**TUSCARAWAS COUNTY COMMISSIONERS  
TUSCARAWAS COUNTY, OHIO**

**CONTRACT 2 – WILKSHIRE HILLS WATER SYSTEM IMPROVEMENTS**

**ADDENDUM #3**

**THRASHER PROJECT #101-010-01120**

TUSCARAWAS COUNTY  
 METROPOLITAN SEWER DISTRICT  
 WILKSHIRE HILLS WATER SYSTEM IMPROVEMENTS  
 PROPOSED PRESSURE FILTER BACKWASH TANK  
 DETAILS

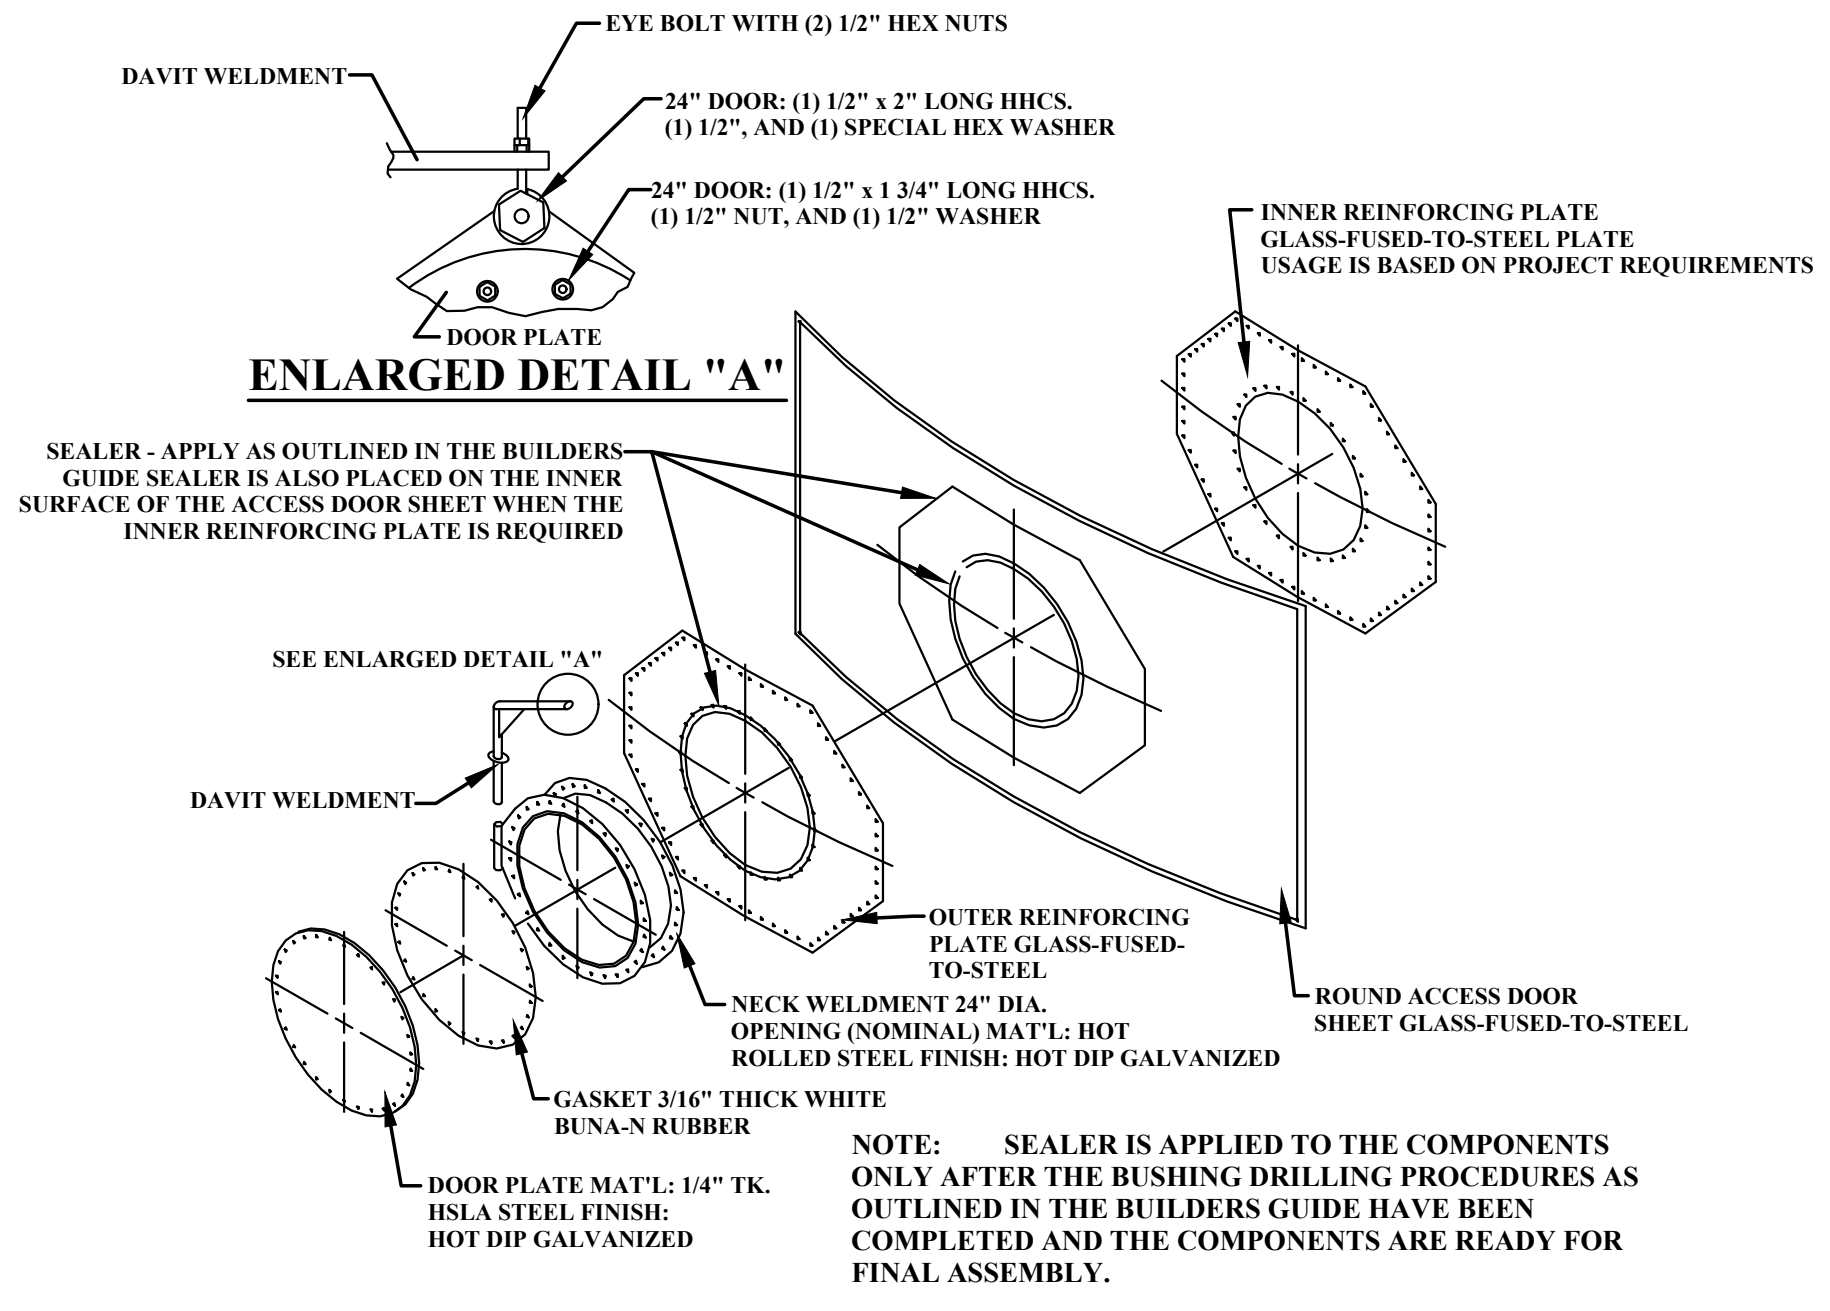
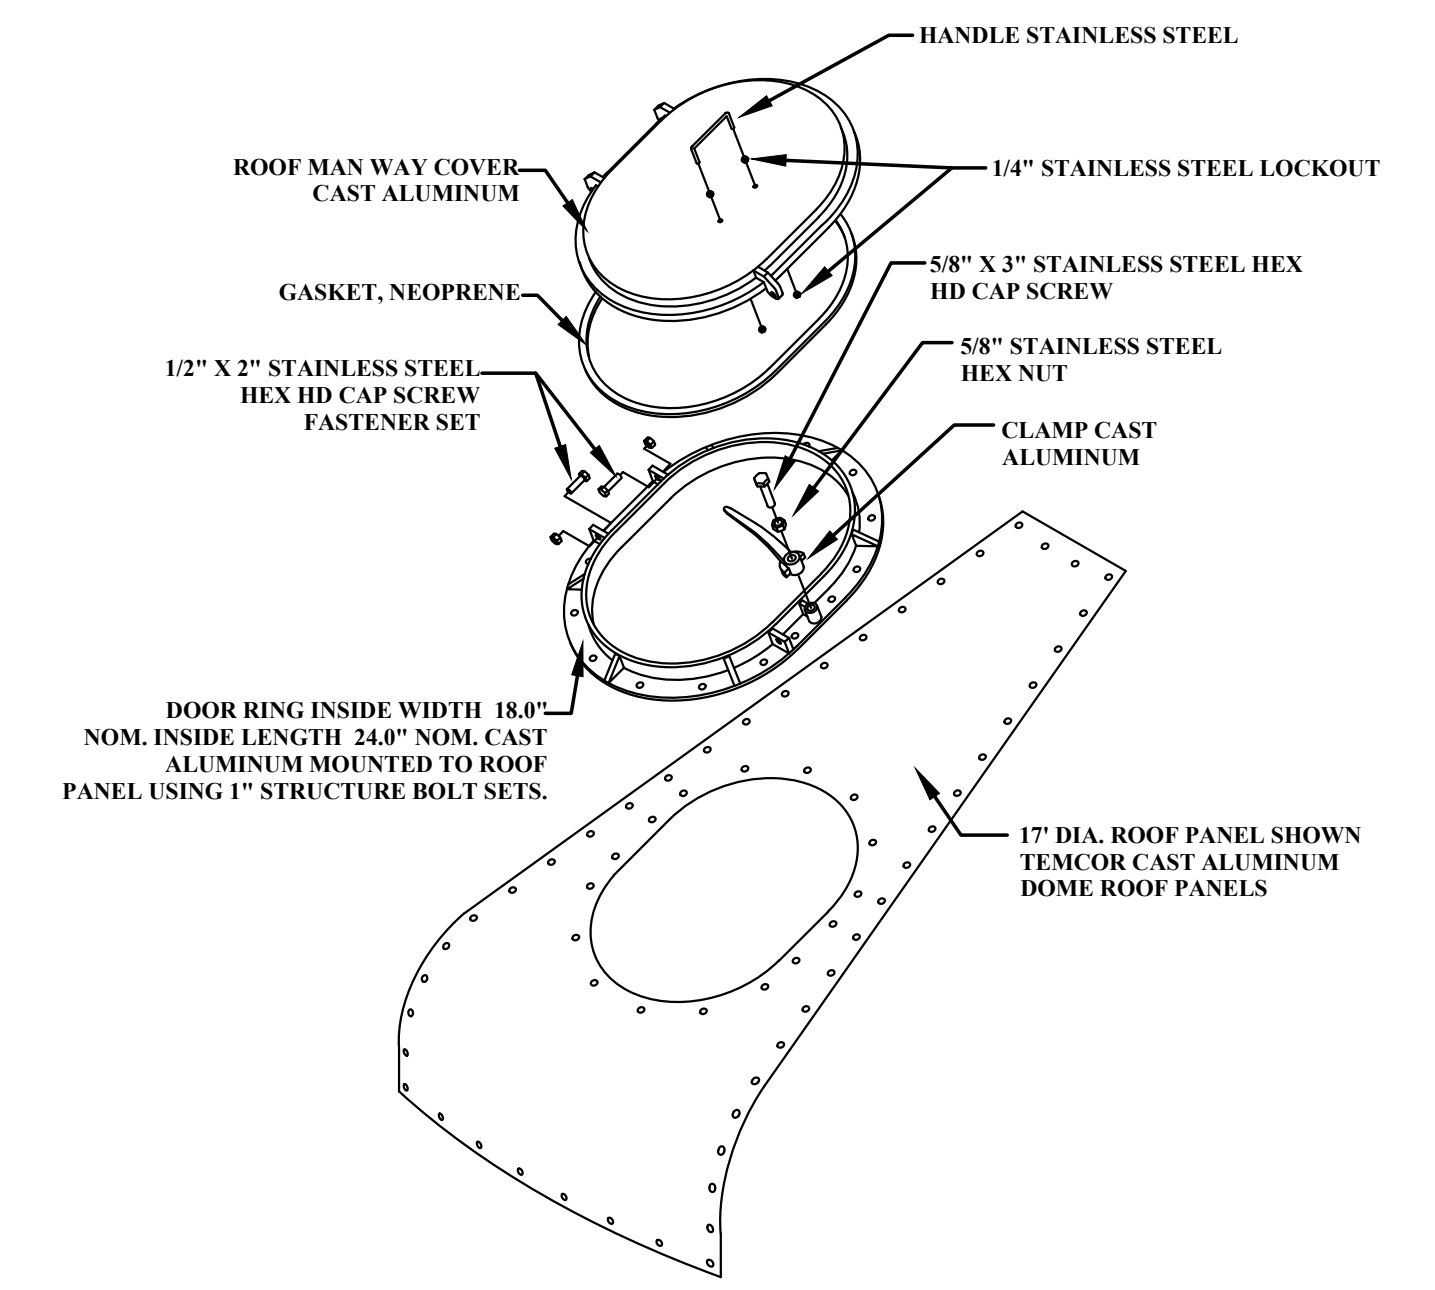
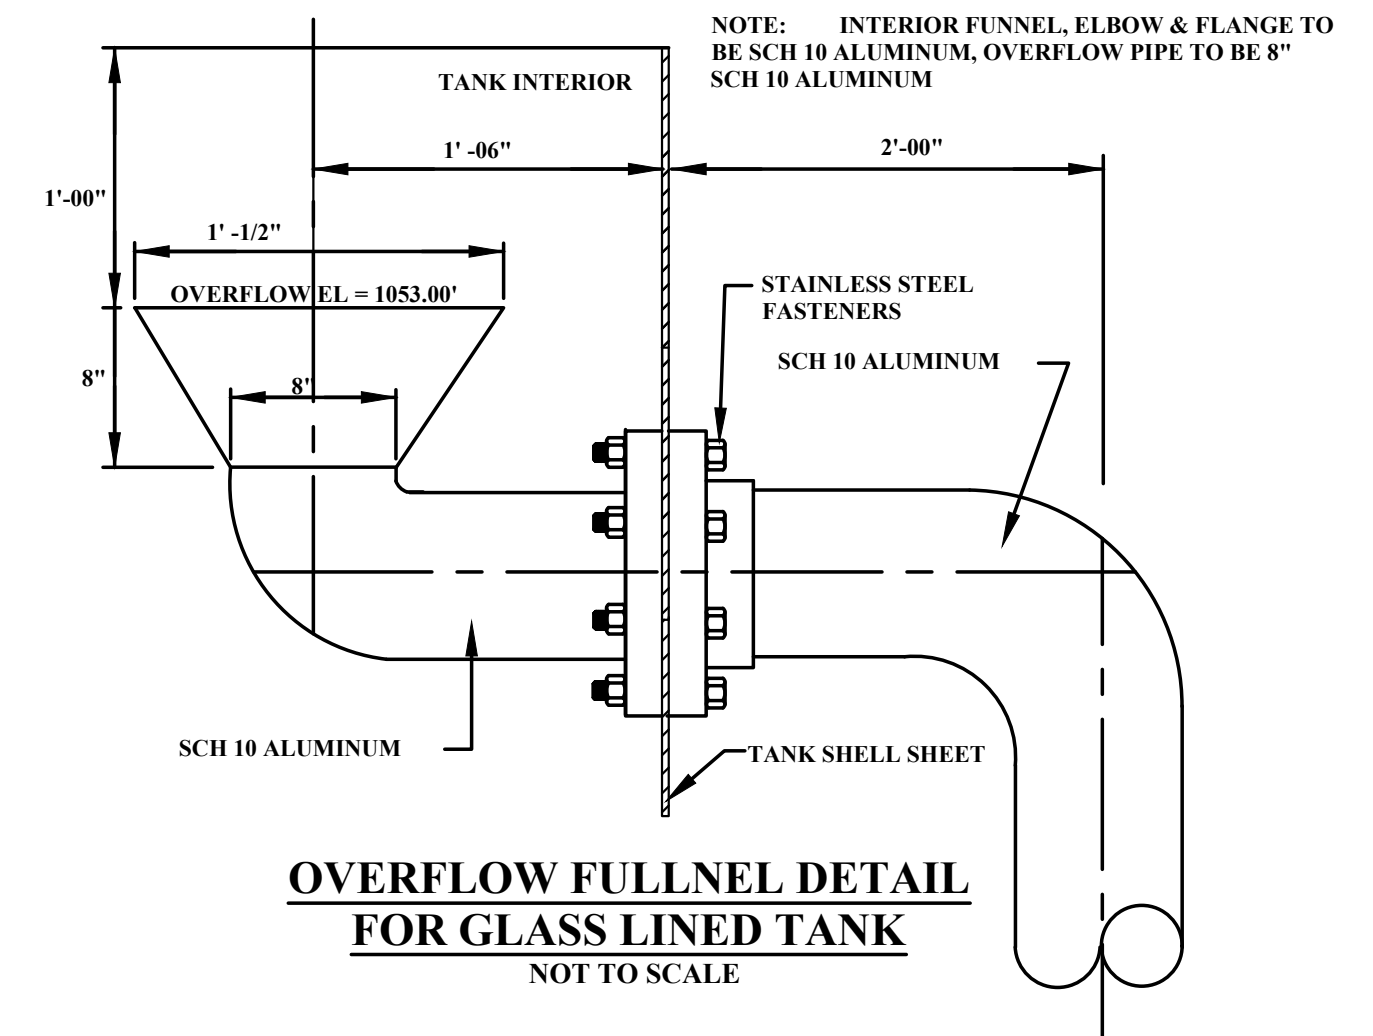
1. **GENERAL**  
**REPLACE** page 5 of the Index with the attached. Revised the name of spec. 331613.
2. **SPECIFICATIONS**  
**REPLACE** Specification 331613 Above Ground Water Utility Storage Tanks with attached Specification for Glass-Coated, Bolted-Steel Potable Water Tank AWWA Design.
3. **DRAWINGS**  
**REPLACE** Sheets 9 and 9A with the attached Sheets 9 and 9A.
4. **QUESTIONS & RESPONSES**

NO.	BY	DATE	DESCRIPTION
2	SMD	1MAR2023	REVISED TANK DESIGN & SPECS
1	SMD	8DEC2022	QA/QC REVIEW
